CONTRACT CHANGE ORDER No. 170
SHEET ___ OF ___

ROADWAY LEVEL EASTBOUND
LIGHTING AND ELECTRICAL SYSTEMS
SCALE: 1:200

ROADWAY LIGHTING POLE LOCATION PLAN-SHEET 45
SKYWAY STRUCTURES
NO SCALE

E-64

EE-45

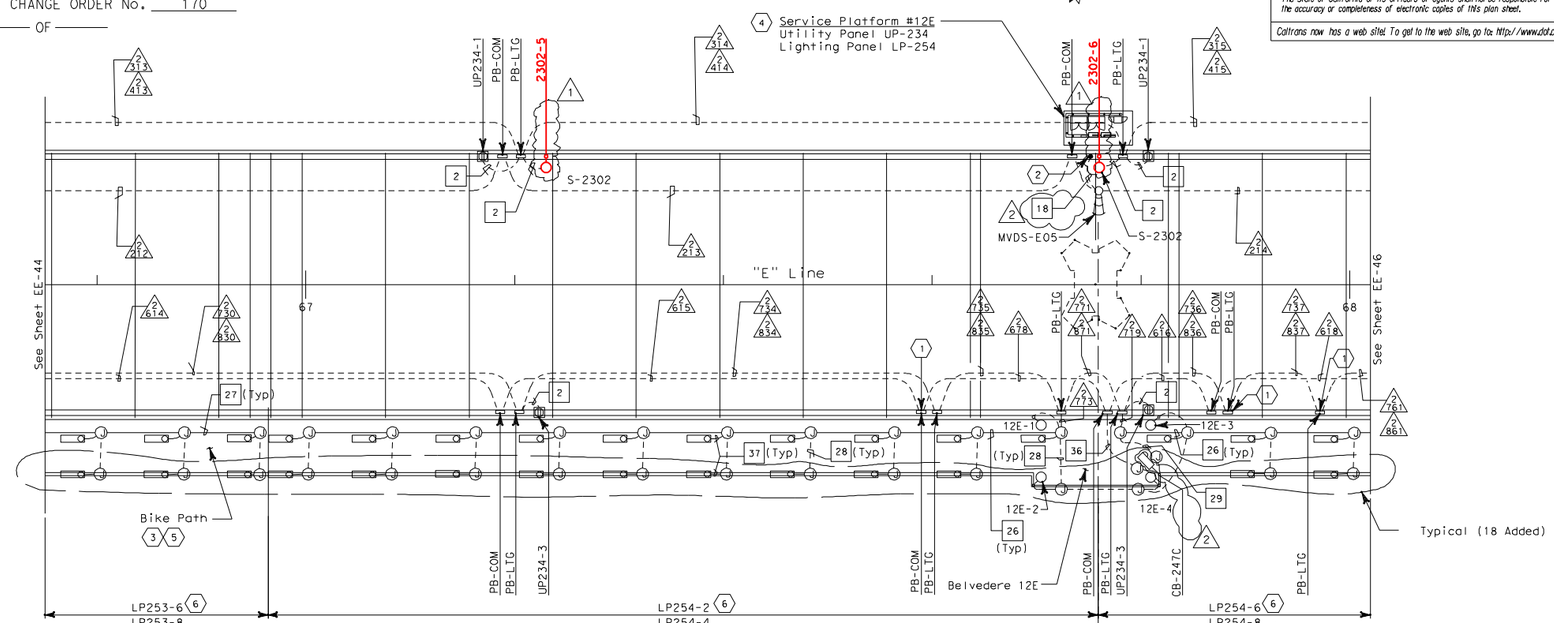
MARK	DATE	DESCRIPTIONS	REV	CK	
2	1/20/06	Delete CB-247C. Coil 5 m of call box signal and power cable in adjacent PB-COM and PB-LTG pull boxes. Delete MVDS cable harness only.	JE	EJL	CCO No. 170
1	3/2/05	Delete Roadway light poles and fixtures. Coil 10m, 3#10 conductors in the pull box adjacent to light pole locations.	RS	PB	CCO No. 123
